NIAGARA MOHAWK POWER CORPORATION
LICENSE NO. DPR-63
DOCKET NO. 50-220

Proposed Changes to the Current Technical Specifications (TS)

Replace existing pages 84, 85, 86, 87, 88, 89, 90, 91, 92, 93, 94, and 95 with the attached revised pages. These pages have been retyped in their entirety with marginal markings to indicate changes to the text. Also, pages 94a, 94b, 94c, and 94d have been added.

Marked Up Copy of Technical Specifications

FIGURE 3.2.2.a

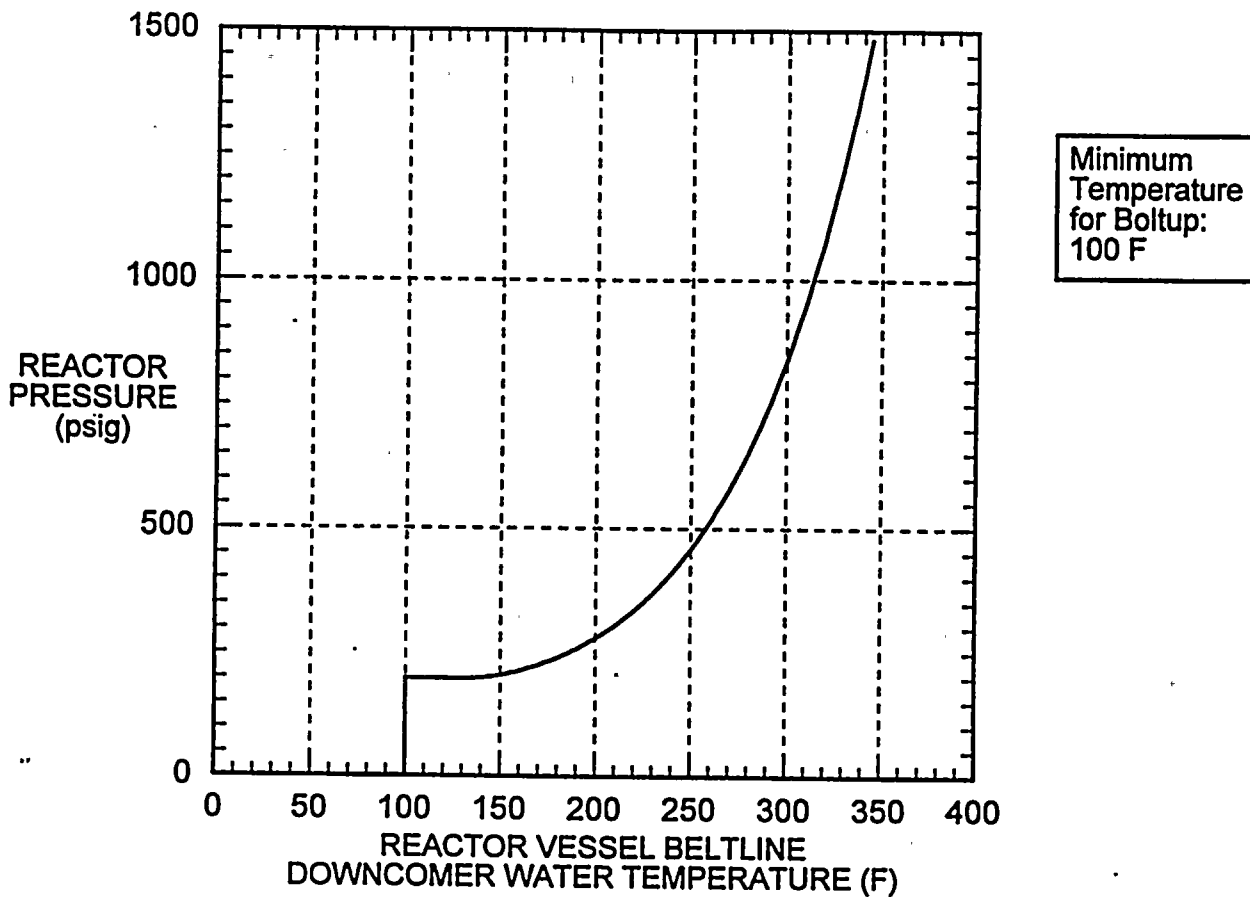
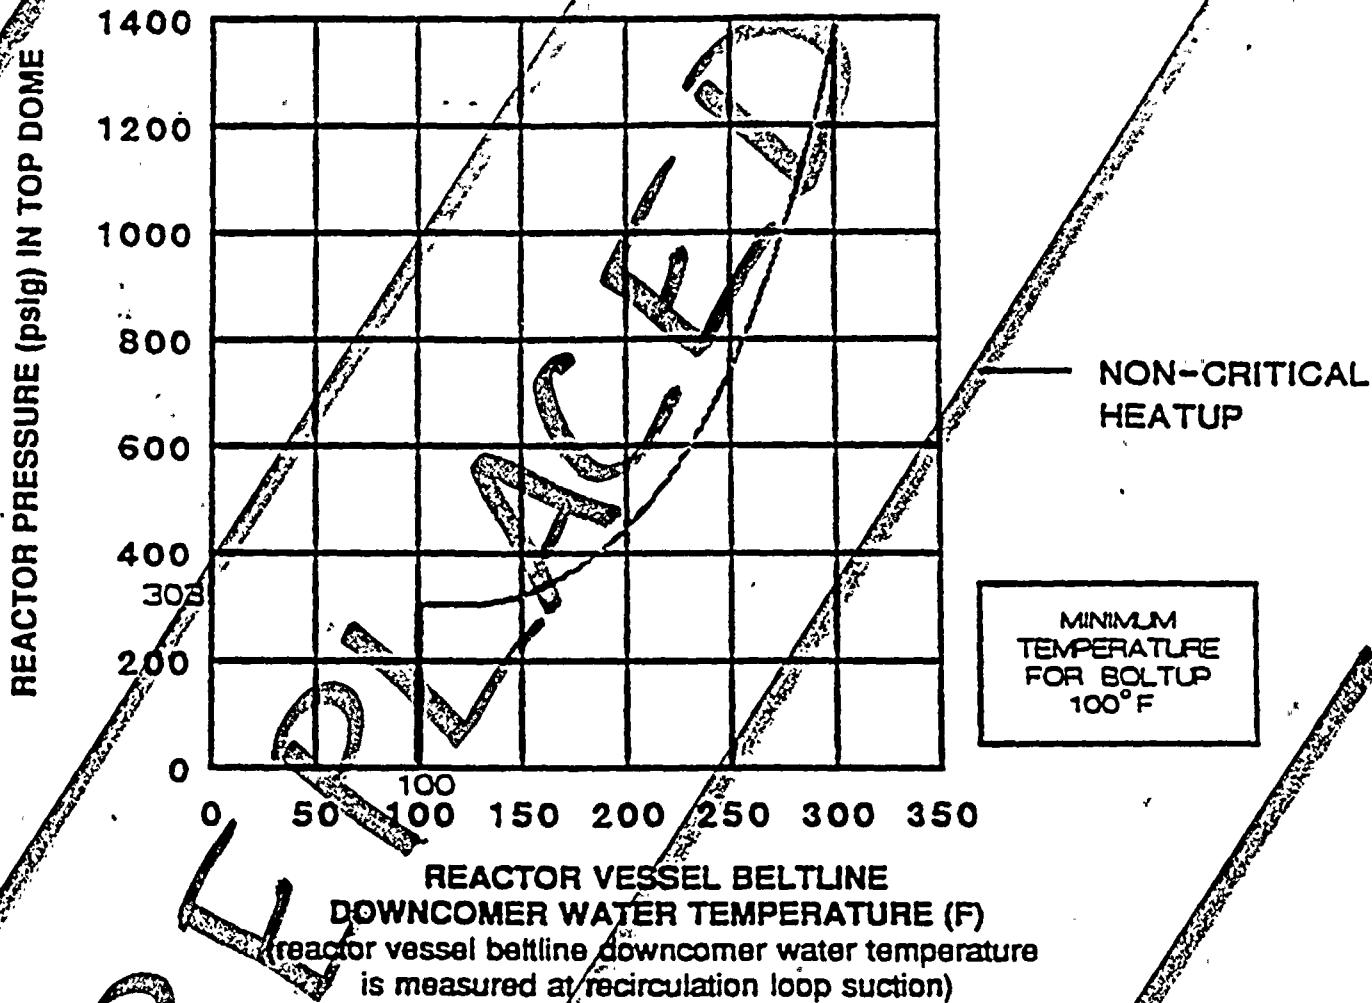
MINIMUM BELTLINE DOWNCOMER WATER TEMPERATURE FOR
PRESSURIZATION DURING HEATUP AND LOW-POWER PHYSICS
TESTS (CORE NOT CRITICAL) (HEATING RATE $\leq 100^\circ\text{F/HR}$)
FOR UP TO 28 EFFECTIVE FULL POWER YEARS OF OPERATION

MINIMUM BELTLINE DOWNCOMER WATER TEMPERATURE FOR PRESSURIZATION DURING HEATUP AND LOW-POWER PHYSICS TESTS (REACTOR NOT CRITICAL) (HEATING RATE $\leq 100^\circ\text{F}/\text{HR}$) FOR UP TO 18 EFFECTIVE FULL POWER YEARS OF OPERATION

REPLACED

FIGURE 3.2.2.b

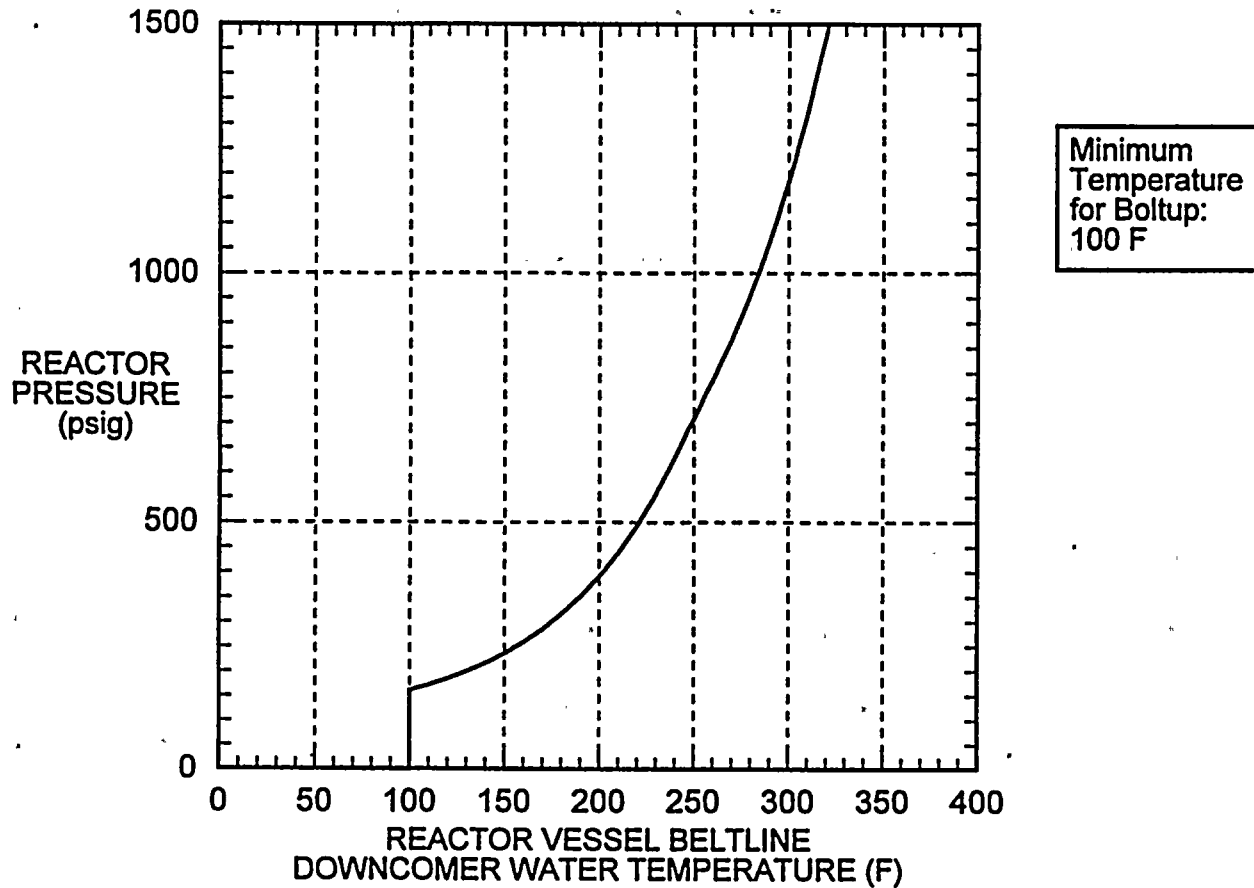
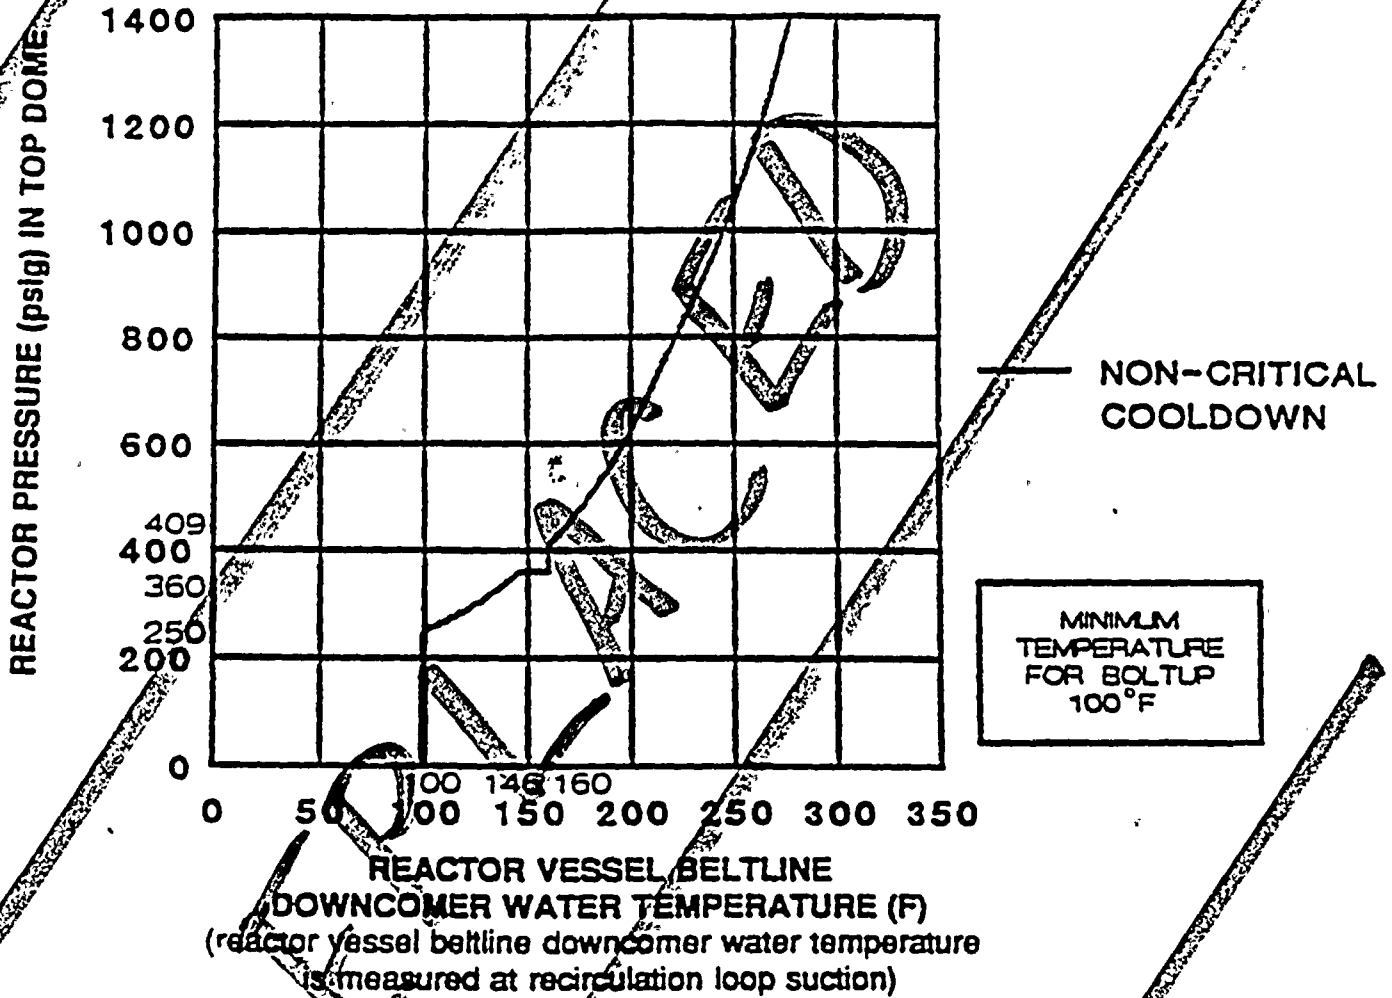
**MINIMUM BELTLINE DOWNCOMER WATER TEMPERATURE FOR
PRESSURIZATION DURING COOLDOWN AND LOW-POWER
PHYSICS TESTS (CORE NOT CRITICAL) (COOLING RATE $\leq 100^\circ\text{F}/\text{HR}$)
FOR UP TO 28 EFFECTIVE FULL POWER YEARS OF OPERATION**

MINIMUM BELTLINE DOWNCOMER WATER TEMPERATURE FOR
 PRESSURIZATION DURING COOLDOWN AND LOW-POWER
 PHYSICS TESTS (REACTOR NOT CRITICAL) (COOLING RATE $\leq 100^\circ\text{F}/\text{HR}$)
 FOR UP TO 18 EFFECTIVE FULL POWER YEARS OF OPERATION

REPLACED

FIGURE 3.2.2.c

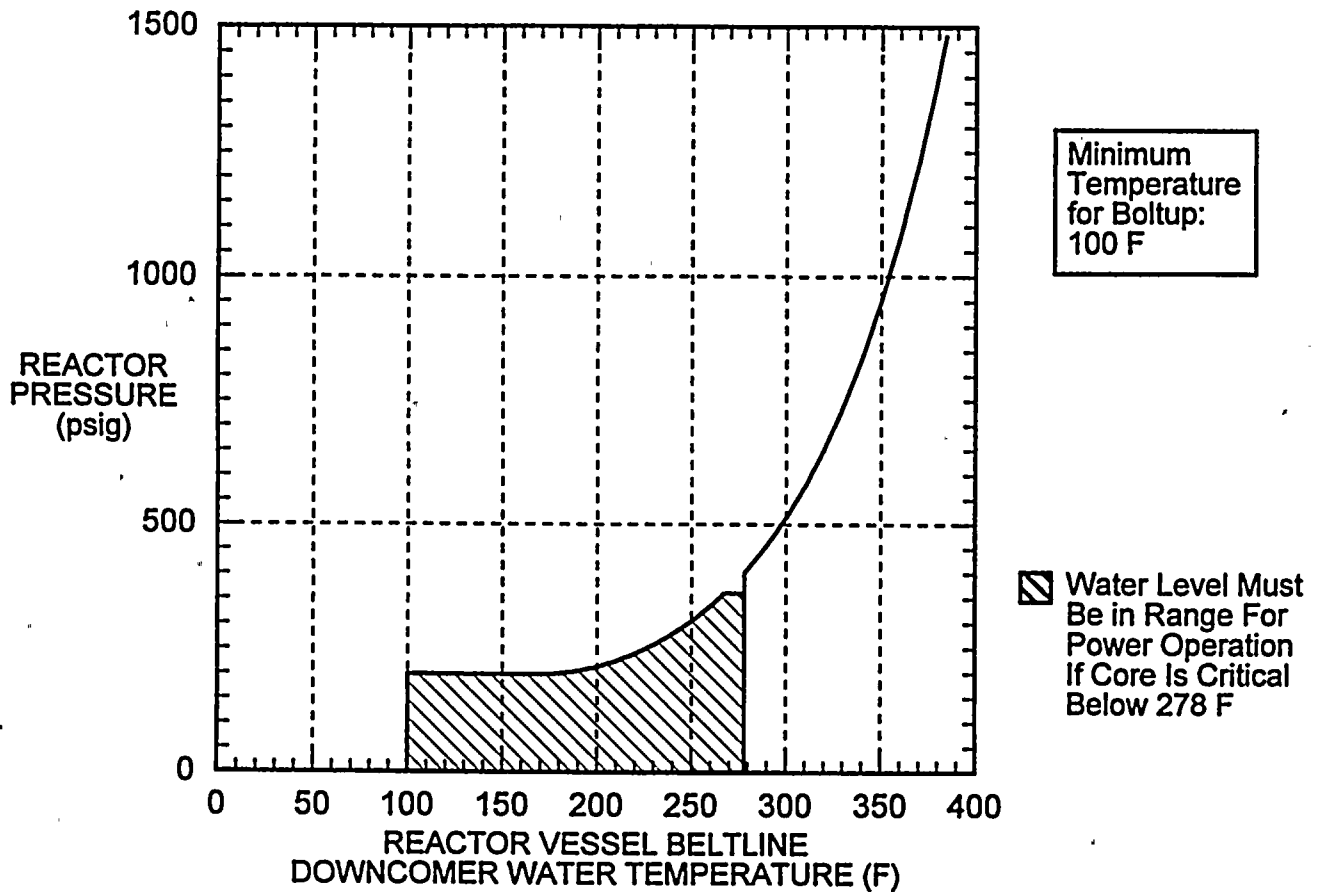
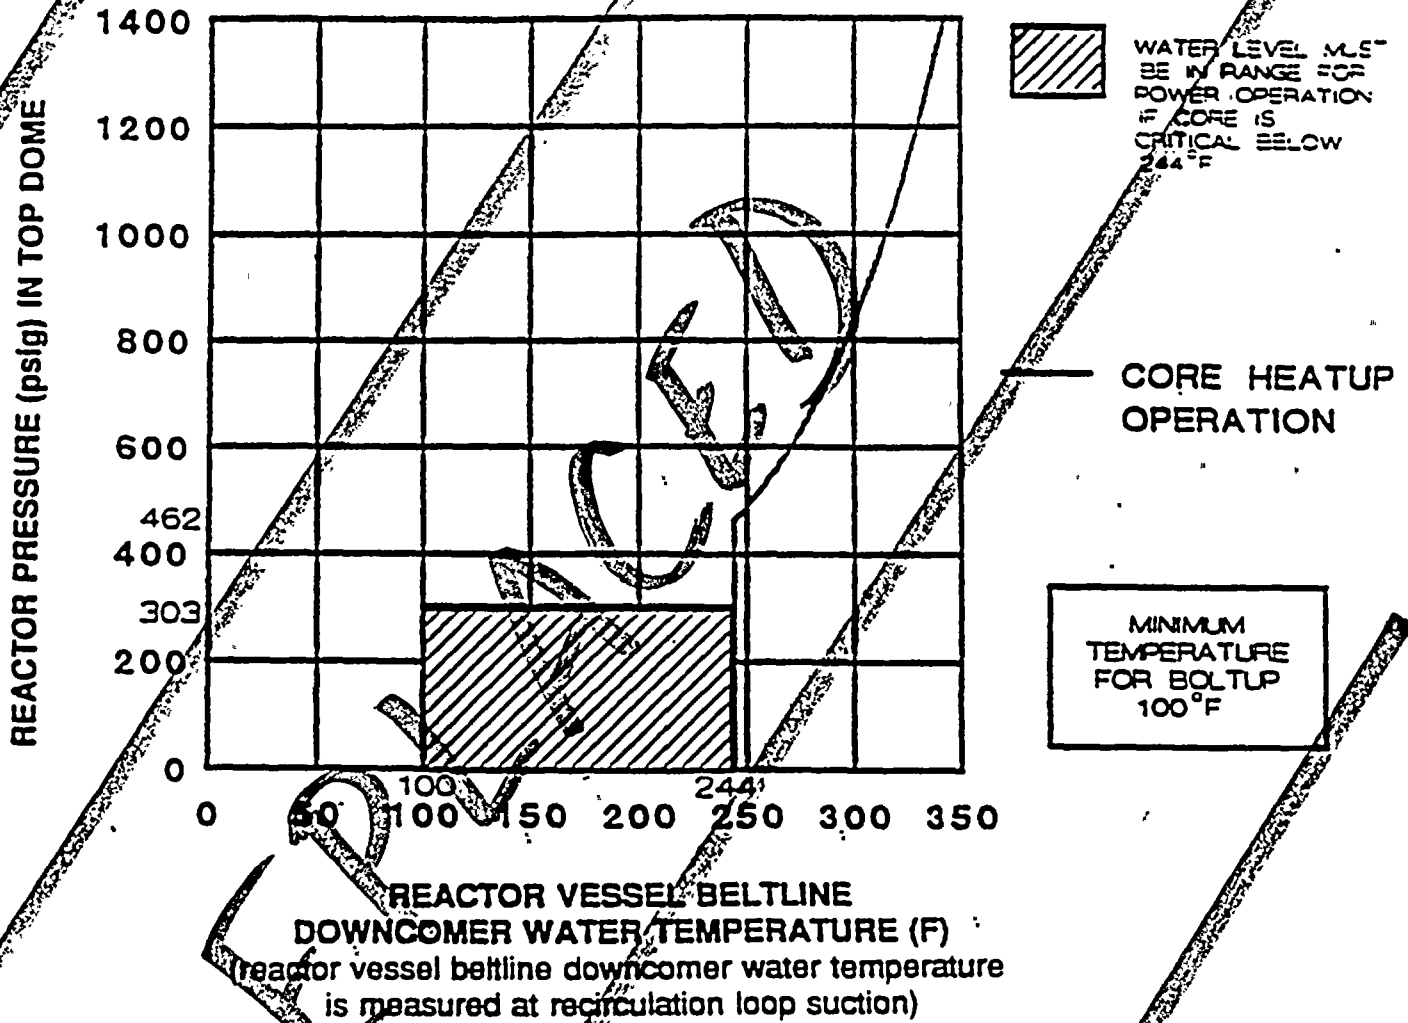
MINIMUM BELTLINE DOWNCOMER WATER TEMPERATURE
 FOR PRESSURIZATION DURING CORE OPERATION
 (CORE CRITICAL) (HEATING RATE $\leq 100^\circ\text{F}/\text{HR}$) FOR UP TO
 28 EFFECTIVE FULL POWER YEARS OF OPERATION

MINIMUM BELTLINE DOWNCOMER WATER TEMPERATURE FOR PRESSURIZATION DURING CORE OPERATION (CORE CRITICAL) (HEATUP AT A HEATING RATE $\leq 100^\circ\text{F}/\text{HR}$) FOR UP TO 18 EFFECTIVE FULL POWER YEARS OF OPERATION

REPLACED

FIGURE 3.2.2.d

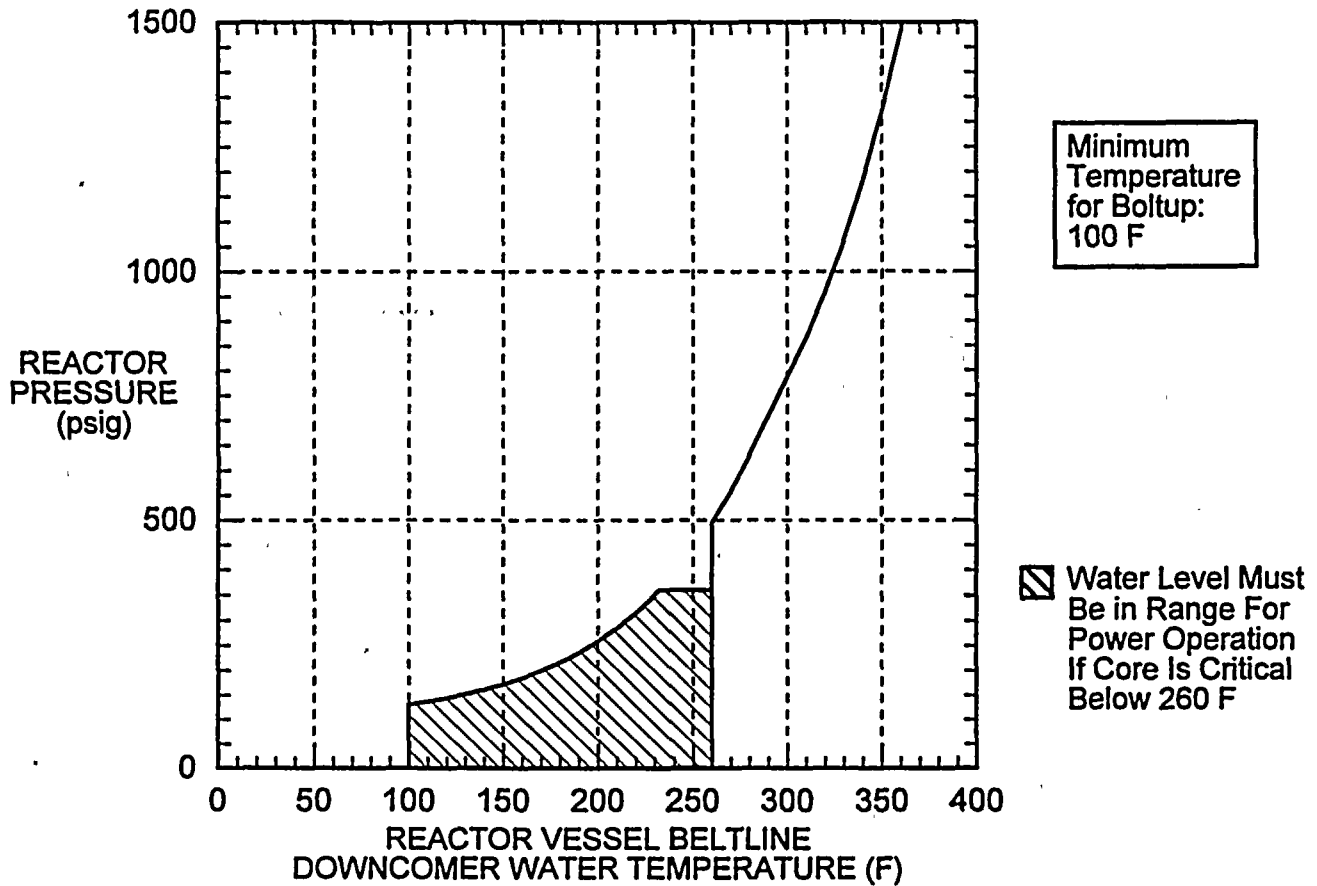
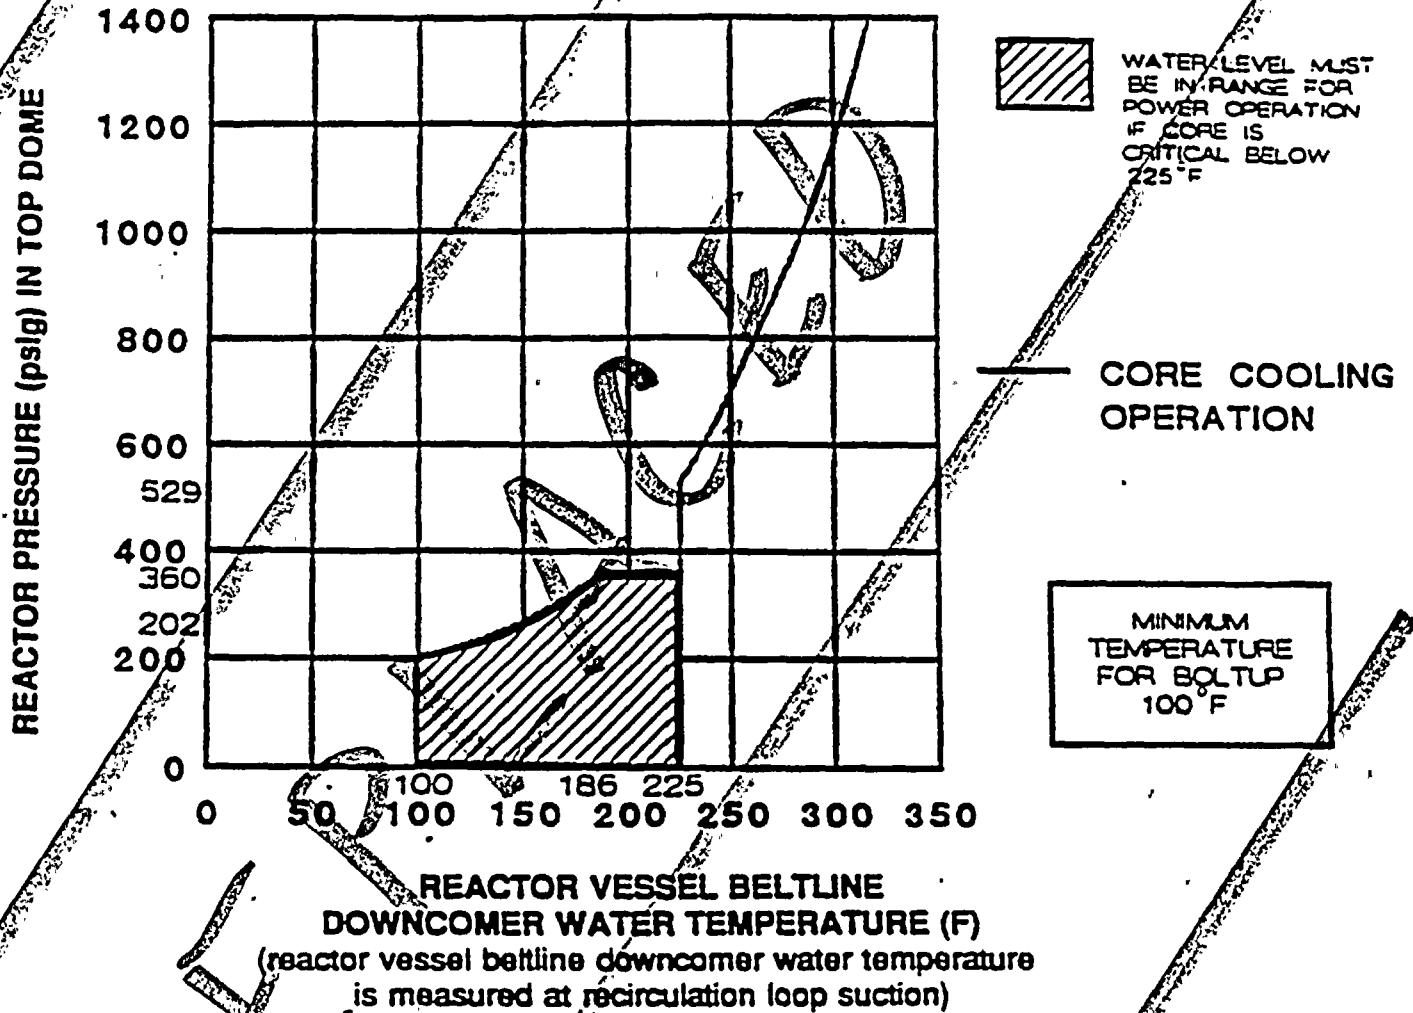
**MINIMUM BELTLINE DOWNCOMER WATER TEMPERATURE
 FOR PRESSURIZATION DURING CORE OPERATION
 (CORE CRITICAL) (COOLING RATE $\leq 100^\circ\text{F}/\text{HR}$) FOR UP TO
 28 EFFECTIVE FULL POWER YEARS OF OPERATION**

MINIMUM BELTLINE DOWNCOMER WATER TEMPERATURE FOR PRESSURIZATION DURING CORE OPERATION (CORE CRITICAL) (COOLDOWN) AT A COOLDOWN RATE $\leq 100^\circ\text{F}/\text{HR}$ FOR UP TO 18 EFFECTIVE FULL POWER YEARS OF OPERATION

REPLACED
